Final Drainage Report  
Terra Ridge North  
Colorado Springs, Colorado 80908

Prepared by:  
Lodestar Engineering, LLC  
PO Box 88461  
Colorado Springs, CO 80908  
Phillip Shay Miles, PE  
719-352-8886

April 20, 2023  
PCD File# SF2239

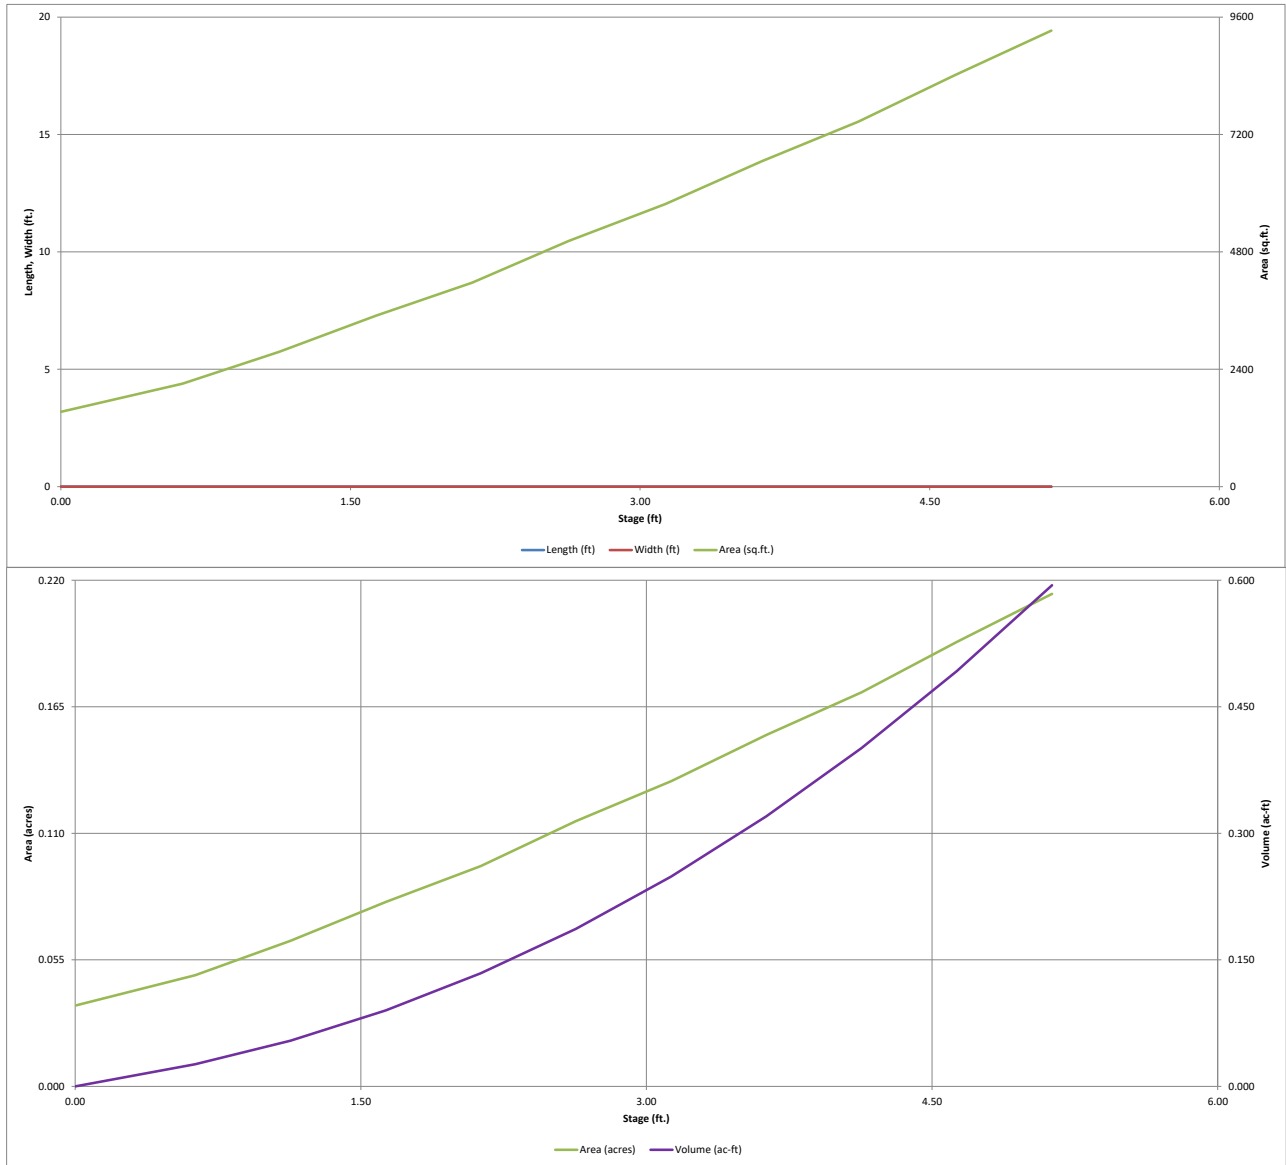
Why "N?" One is provided on the CDs. Per my comment on the CDs with Review 2, I asked that you complete this Step 9 to determine which type of microscreen is acceptable. The type that you have spec'd out is likely not acceptable for the orifice sizes. Revise this to "Y" and see what Type of Screen is specified and revise CDs accordingly.

DEVELOPED DRAINAGE PLAN

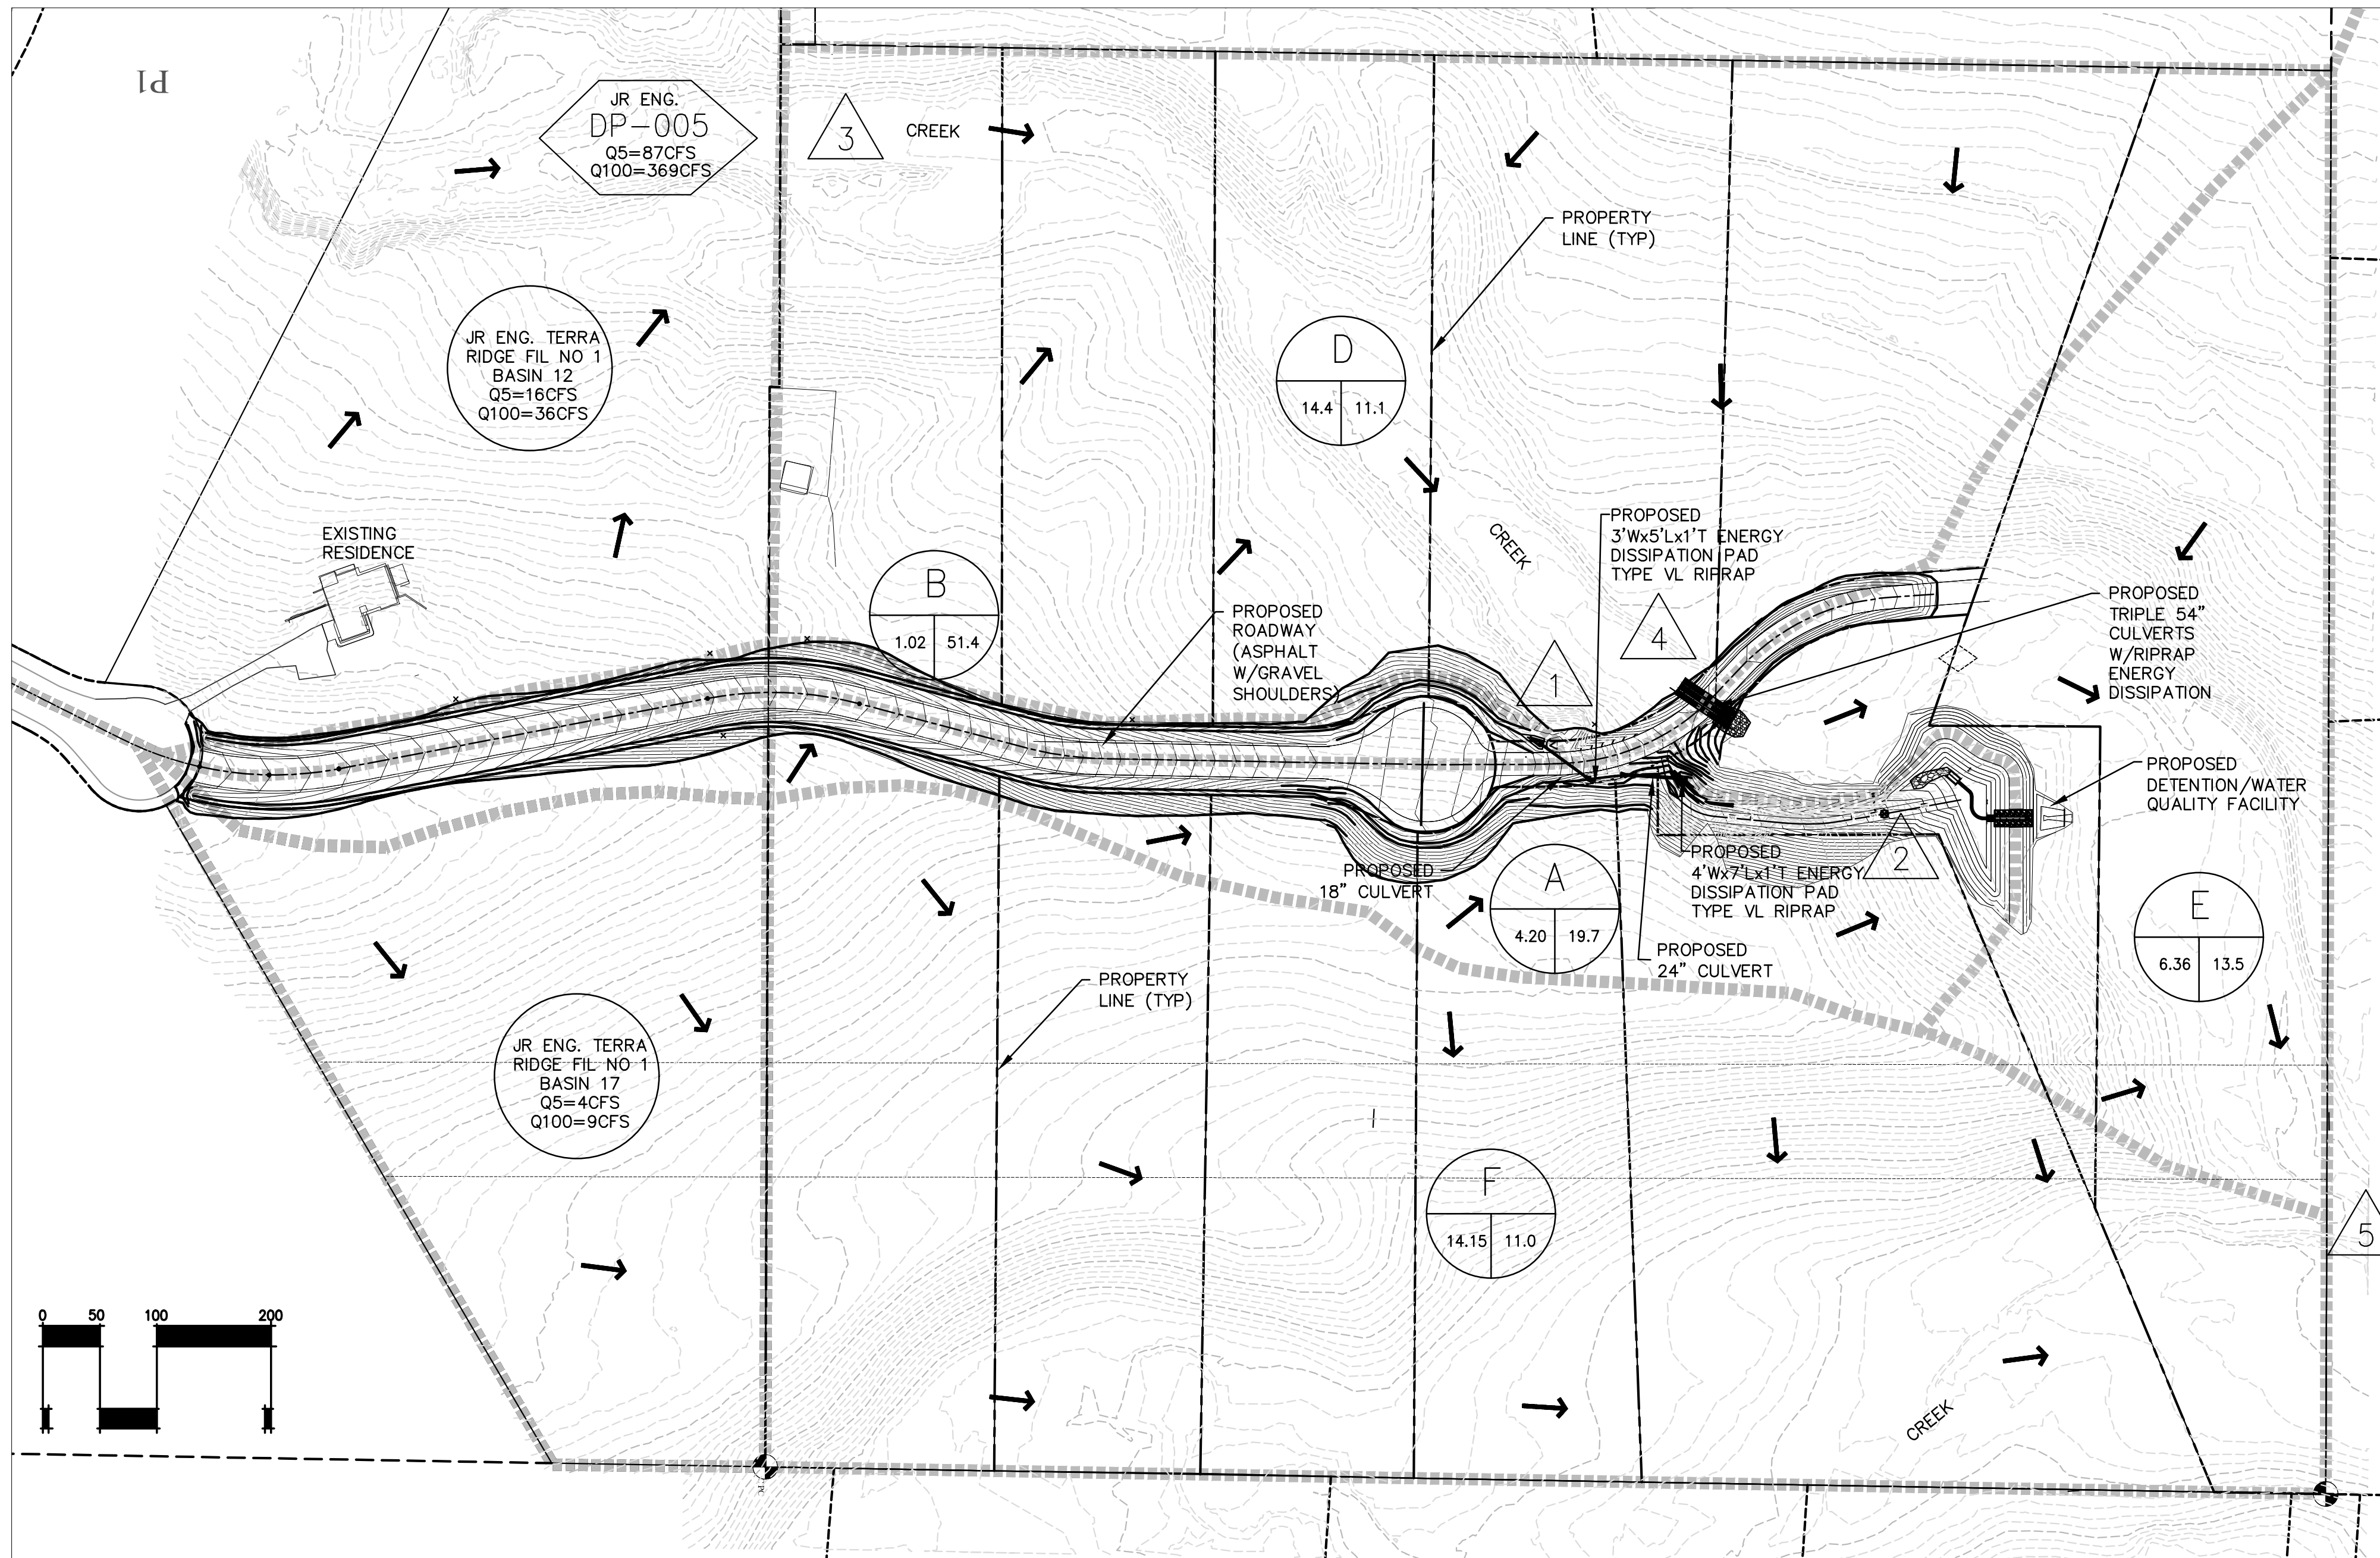
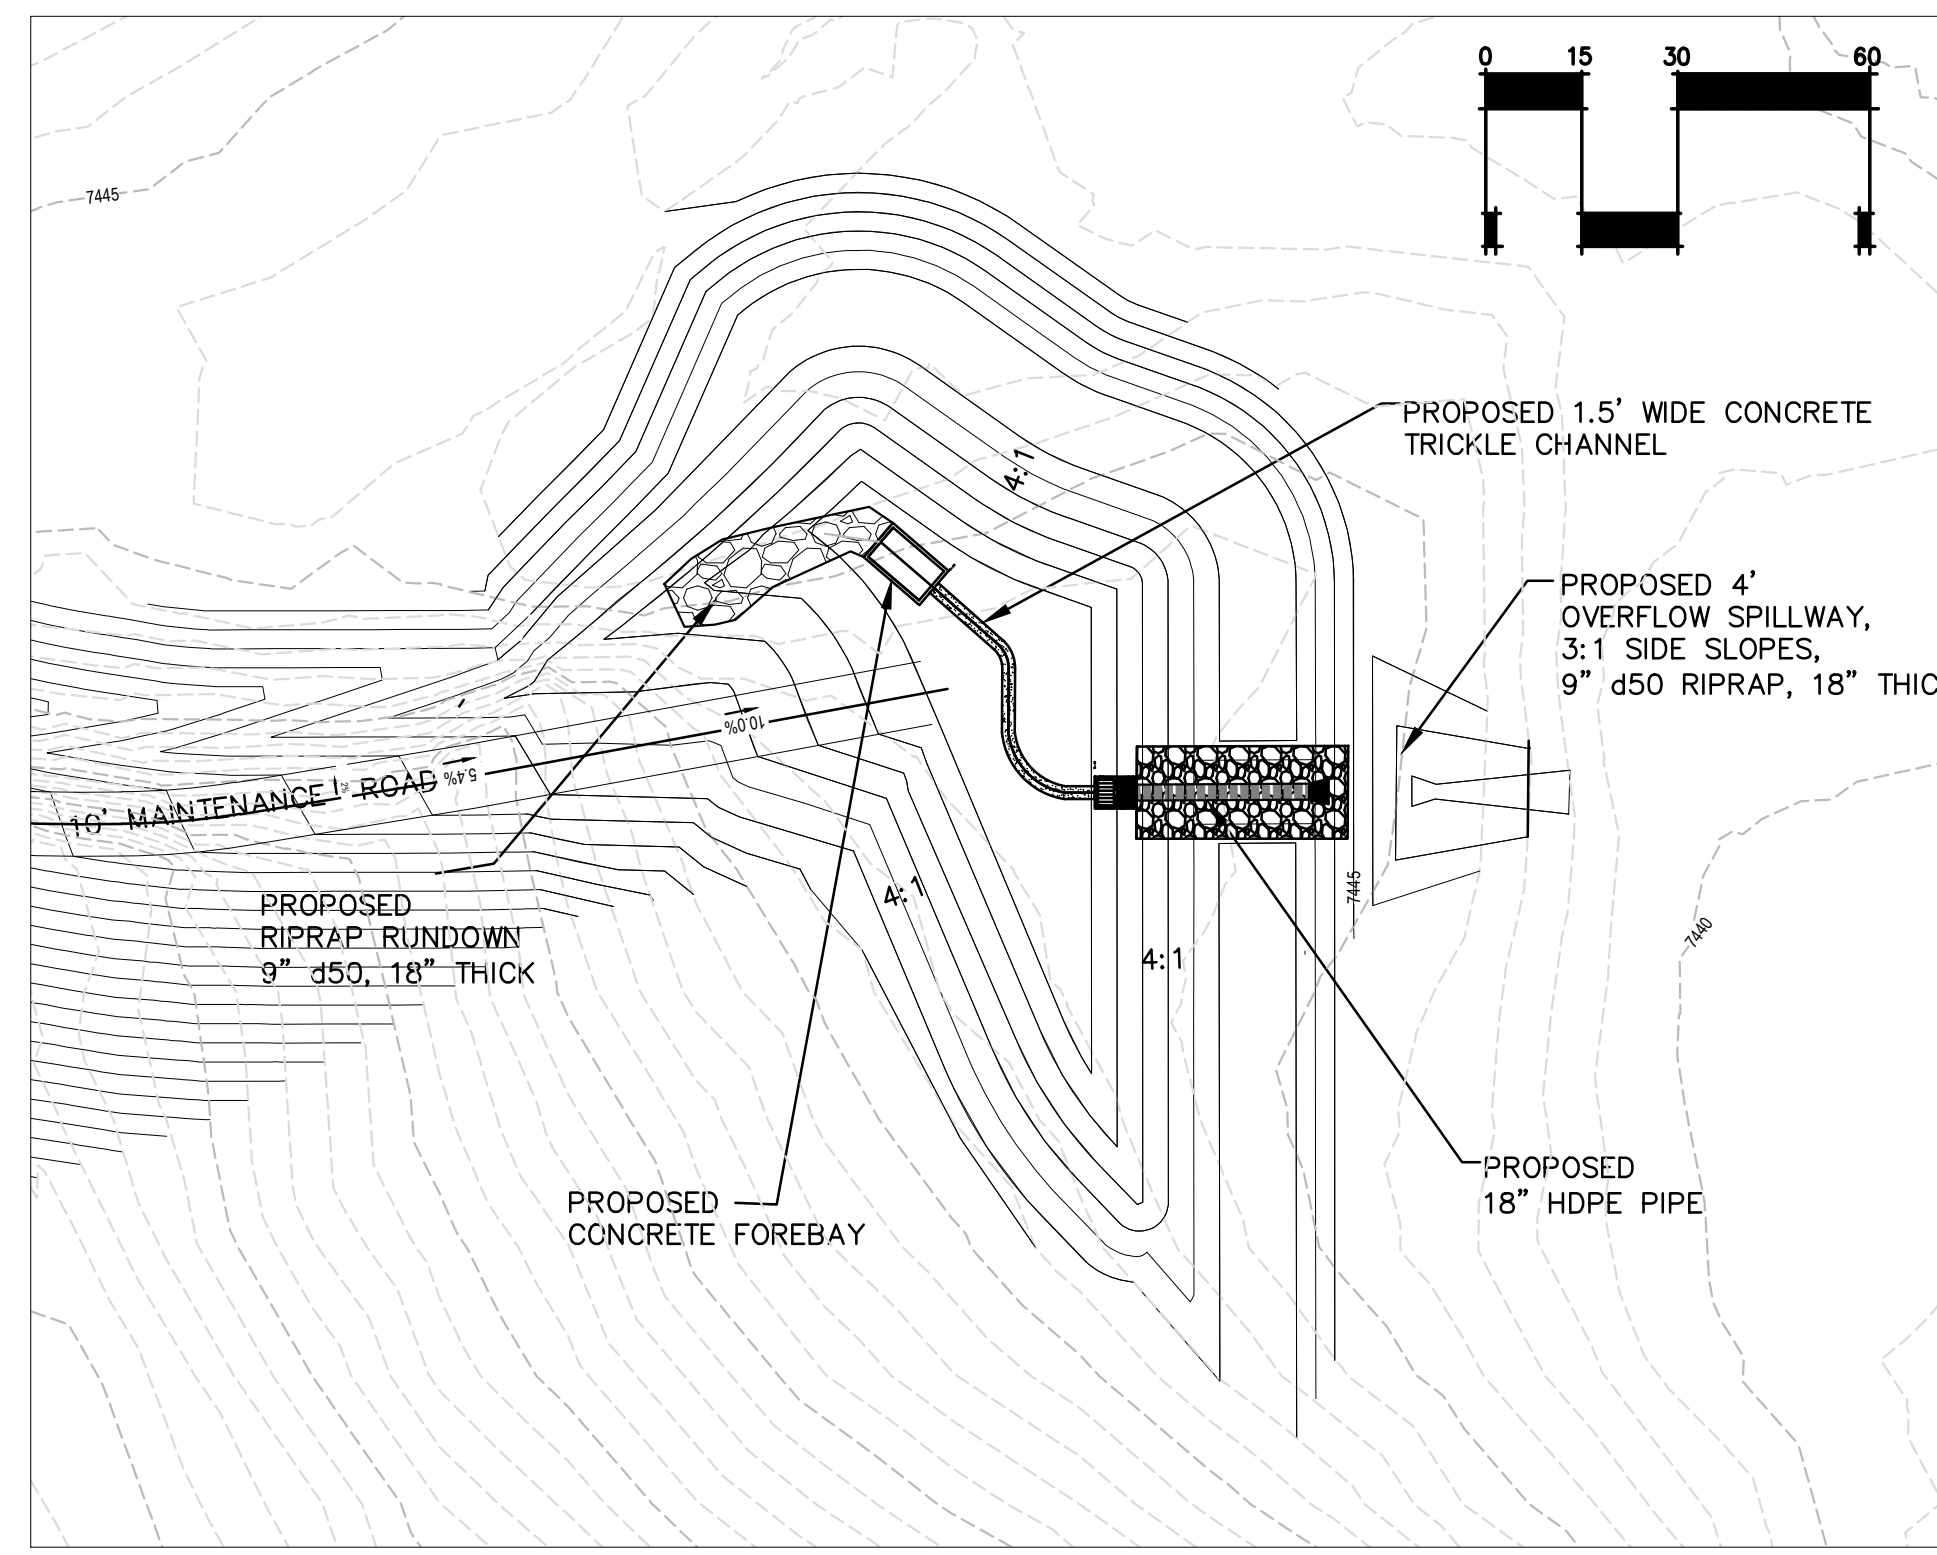
### Review 2 comment:

This is a follow-up to my Review 1 comment on the drainage map about untreated proposed soil disturbances in Basin D:

For this site, I recommend you look into utilizing Runoff Reduction (RR) for WQ treatment per MHFD Detail T-0. MHFD has a calculation spreadsheet for RR. See further guidance in my comment at the bottom of pdf page 11 below.

These disturbances are not applicable to this exclusion because the grading is for the development of the roadway, not the residential lots. Thus I've been asking you to do Runoff Reduction or some WQ treatment PBMP. Previous Review 2 comment provided at bottom of this page for reference.
